INDESIT company

Model type:
LV460AIX

Commercial code:
F030377

Notices

n1045085: Introduction of new litre counter turbine integrated on air-break.

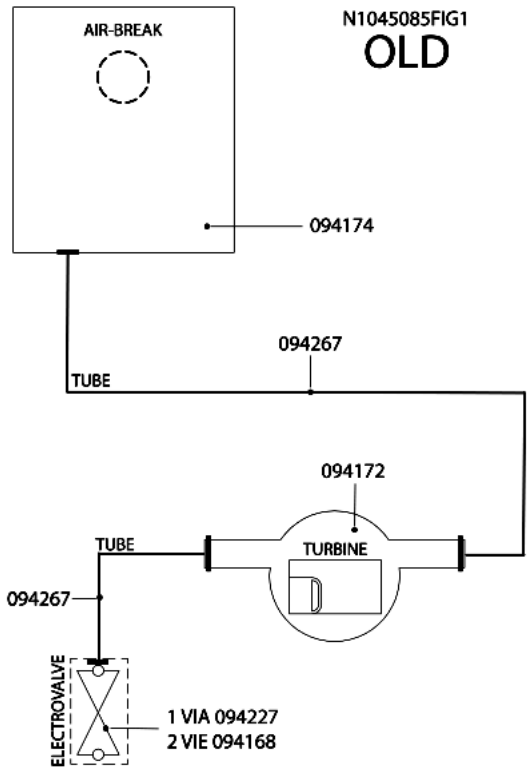
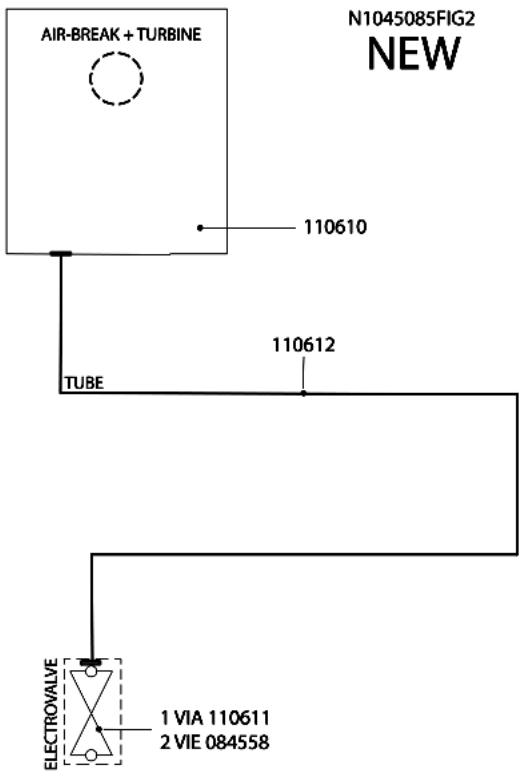
All dishwashers affected by this note have been equipped with a new litre counter turbine on the air-break.
Picture N1045085FIG1 illustrates the premodification structure, picture N1045085FIG2 the new structure.

AIR-BREAK:
new 110610;
premodification 094174;
the new item features a new integrated litre counter turbine and its water supply hose has a smaller diameter.

LITRE COUNTER TURBINE code 094172 has been eliminated.

SOLENOID VALVES:
new:
1-WAY code 110611;
2-WAY code 084558(Rohs 143737);
premodification:
1-WAY code 094227;
2-WAY code 094168;
the new solenoid valves have a smaller diameter drain hose fitting.

HOSES:
new solenoid valve hose/air-break code 110612;
premodification turbine hose/air-break code 094267;
premodification solenoid valve hose/air-break code 094267;
the new hose has a smaller internal diameter.

WIRING:
the litre counter turbine connecting cable is longer, but since the connector is the same, the new item can be used in place of the premodification one.

n1045087: Introduction of recessed heating element.

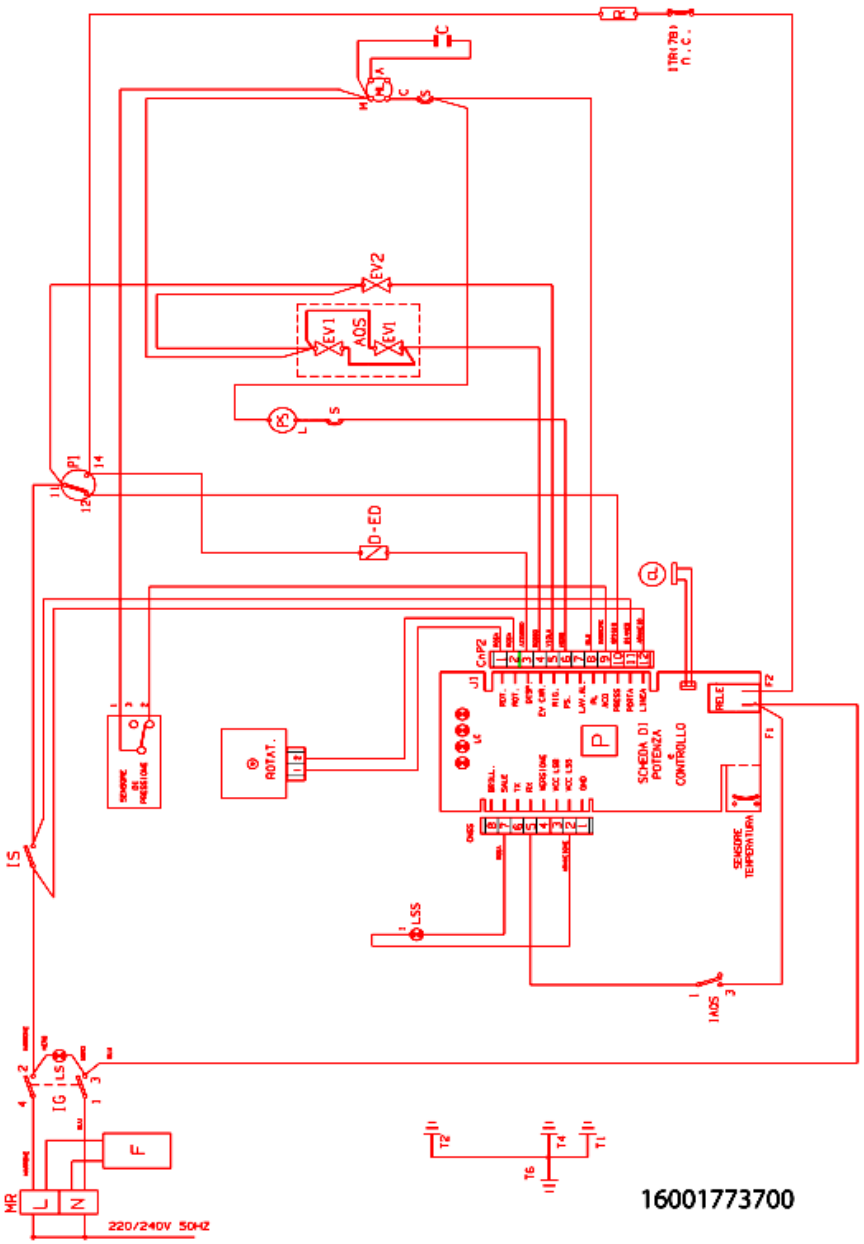
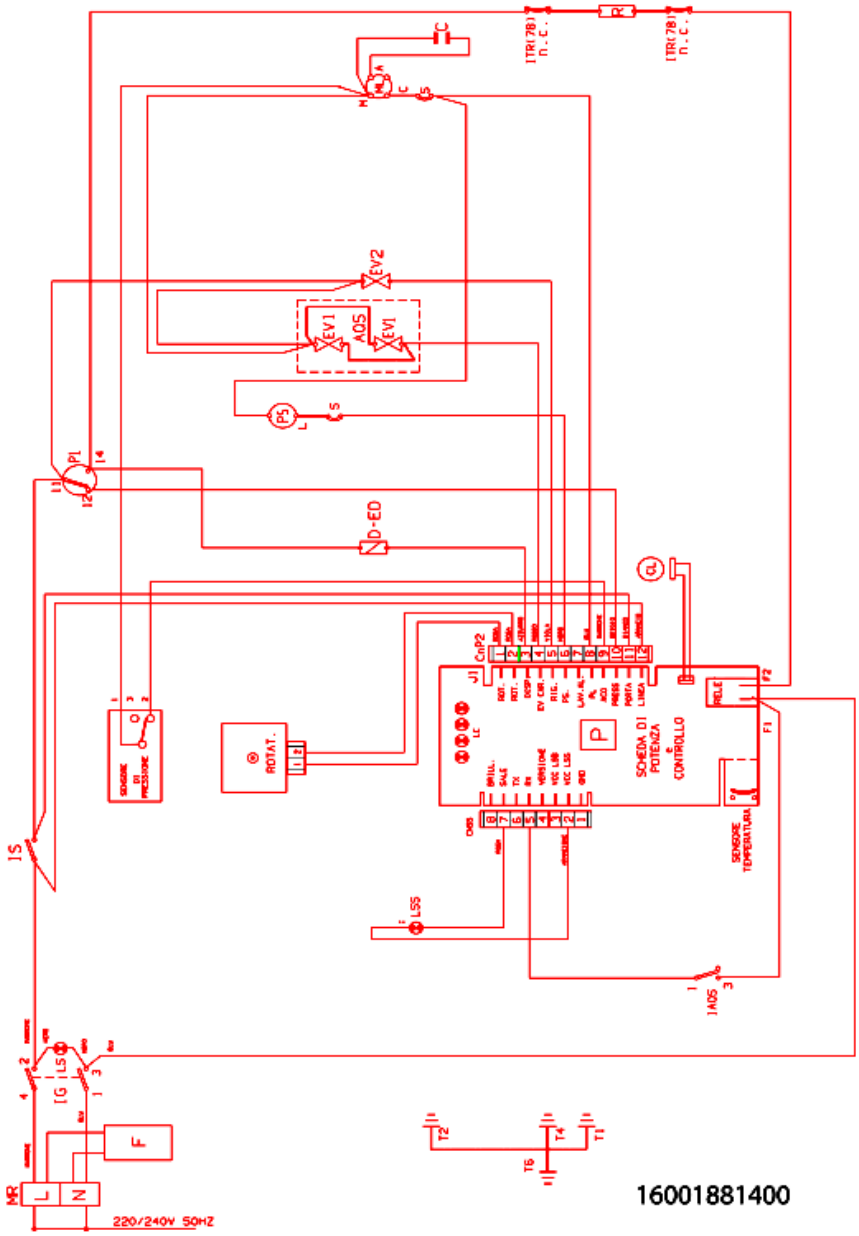
From serial no. 40624.0001, all dishwashers affected by this note have been equipped with a recessed heating element in place of the exposed one located inside the tank.
Given below are the codes of the items concerned:

ELIMINATED ITEMS:
nut + washer code 097871
o-ring seal code 063792
temperature probe code 063791
safety thermostat code 041086
exposed heating element code 066602
heater terminal protection code 074714
upper impeller supply tube code 056001
electrical pump connection tube - upper impeller supply tube code 076233
heater bracket code 054872

INTRODUCED ITEMS:
recessed heating element code 074000
upper impeller supply tube code 094152
heater coupling support code 078394
electrical pump connection tube - heating element code 057710

LV460AIX (comm. code 30377)
Wiring Diagram: premodification 16001773700 new 16001881400
Wiring: premodification 110482 new 112488
